**BULLETIN NO:** 16-007

**TITLE:** PD Workhead Output Shaft Seal

**PRODUCT SERIES / MODEL:** Model 6700SJ2PD Production and Switch Tampers  
(2011-Present)

**5068441 - OUTPUT SHAFT SEALS & FLANGE KIT**

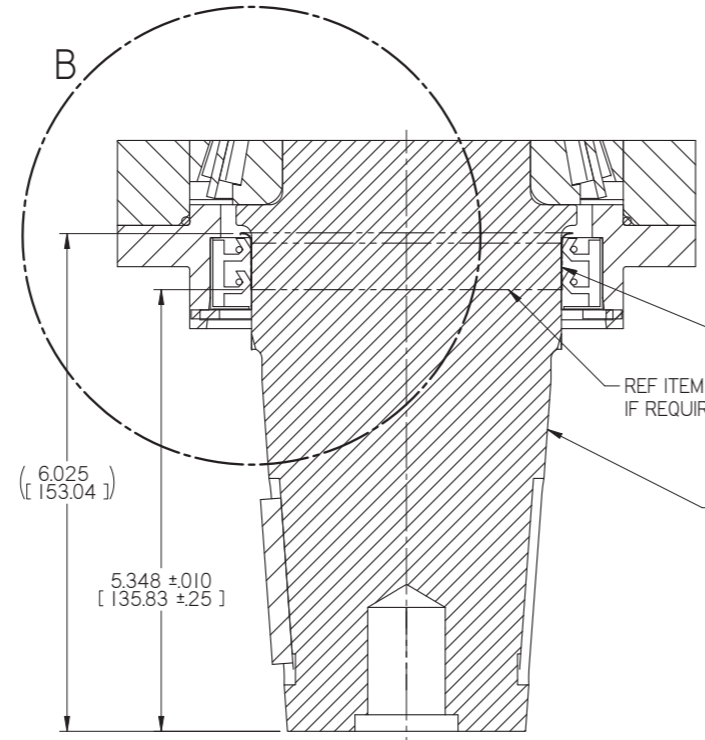
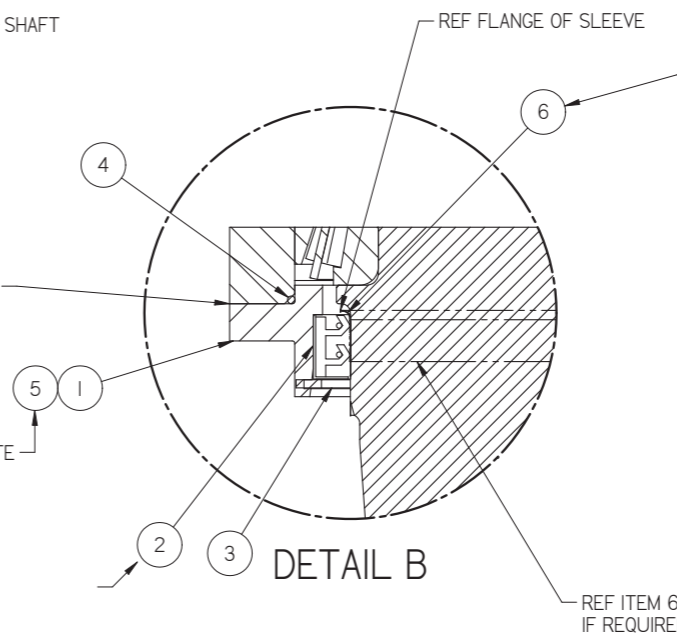
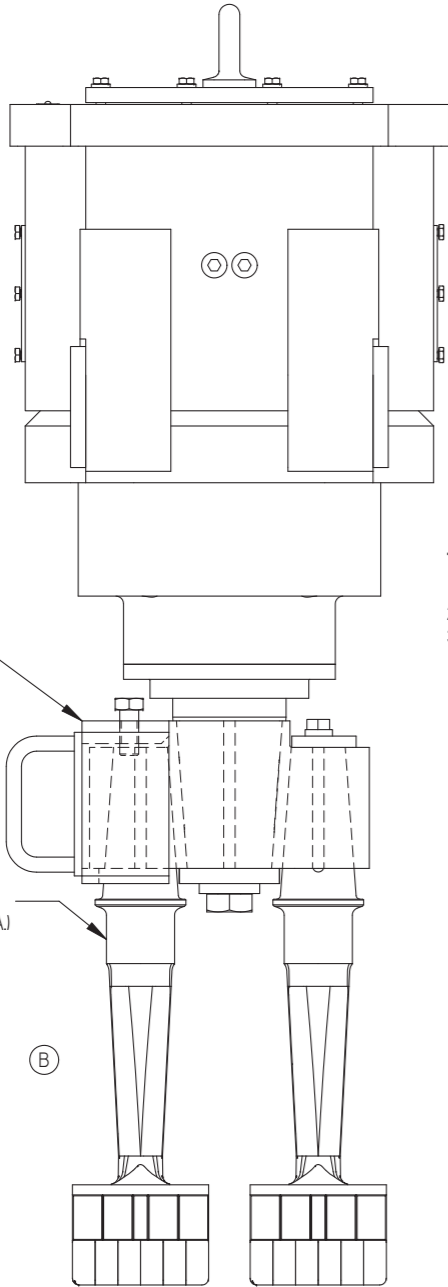
**SUMMARY:** **This Service Bulletin will supersede Service Bulletin SB15-015 regarding replacement of PD Workhead Output Shaft Seals.** The positive displacement workhead Vibratory Assemblies (PD Workheads) manufactured since December 2015 with the new two-piece seal design continue to experience output shaft seal leaks. Although these workhead vibrators improved output shaft bearing pre-load retention, the new seal is not working in the application. This Service Bulletin provides the information to revert back to the original seal.

The excessive output shaft end play, and subsequent excessive radial movement of the output shaft is a root cause of the original seals leaking. This root cause has been addressed in PD Vibratory Assemblies manufactured since December 2015.

Replace two-piece seal and flange with Seal and Flange per this Service Bulletin, and provided in Service Kit 5068441.

- a) If original seal (Part No. L40550) is installed, leave as is - replace as needed.
- b) If a PD Workhead seal has been replaced per Service Bulletin 15-015, Seal Kit 5060758, then replace the two-piece Seal and Flange with Seal and Flange per this Service Bulletin and provided in Service Kit 5068441.

**RECOMENDED INSTALLATION TOOLS FOR INSTALLING THIS KIT; (NOT INCLUDED)**  
 5013211 REMOVAL TOOL FOR TOOL HOLDER  
 5068501 SPEEDIE SLEEVE INSTALL TOOL (BLUE COLOR FOR IDENTIFICATION)  
**NOTE: PREVIOUS VERSIONS OF INSTALL TOOL WILL NOT POSITION THE SLEEVE CORRECTLY. USE ONLY THE BLUE TOOL #5068501**

1. REMOVE OLD SEAL, CARRIER AND SEAL. DISCARD PARTS.
2. REMOVE SPEEDIE SLEEVE (IF PRESENT)
3. CLEAN SEALING SURFACE.

1. PRESS ITEM 2, OIL SEAL, INTO ITEM 1, FLANGE, SHAFT SEAL, WITH LIPS FACING TOWARDS INSIDE OF VIBRATOR HOUSING WHEN INSTALLED. IF INSTALLING IN USED FLANGES, APPLY A COAT OF LOCTITE MR GS2 GASKET SEALANT ONTO OUTSIDE DIAMETER OF SEAL.
2. PRESS ITEM 2, OIL SEAL UNTIL IT BOTTOMS OUT IN COUNTER BORE OF ITEM 1, FLANGE, SHAFT SEAL.
3. PACK HIGH TEMPERATURE GREASE, MOBIL GREASE XHP 222, LITHIUM COMPLEX GREASE BETWEEN THE TWO SEAL LIPS
4. LIGHTLY COAT THE 3.750" OUTSIDE DIAMETER (SEAL SURFACE) OF THE VIBRATOR SHAFT WITH HIGH TEMPERATURE GREASE, MOBIL GREASE XHP 222, LITHIUM COMPLEX GREASE.

1. INSTALL BEFORE ITEMS 1, 2, 3, & 4.
2. ENSURE SHAFT & SLEEVE ARE CLEAN. INSPECT SHAFT FOR BURRS, GROOVES AND GOUGES. FILE OFF BURRS. FILL GROOVES AND GOUGES, THEN FILE SMOOTH.
3. INSTALL SLEEVE USING HARSCO TOOL 5068501 (BLUE). STANDARD SKF TOOL AND PREVIOUS DESIGN HARSCO TOOL (YELLOW) WILL NOT PROVIDE THE CORRECT POSITION OF THE SLEEVE. FLANGED END GOES ON FIRST. GENTLY TAP THE CENTER OF TOOL UNTIL BOTTOM OF TOOL IS AGAINST END OF OUTPUT SHAFT TO ACHIEVE DIMENSION SHOWN.
4. MEASURE FROM END OF SHAFT TO EDGE OF SLEEVE, MUST MEASURE 5.348 +/- .010.
5. LUBRICATE SHAFT BEFORE INSTALLING SEAL.
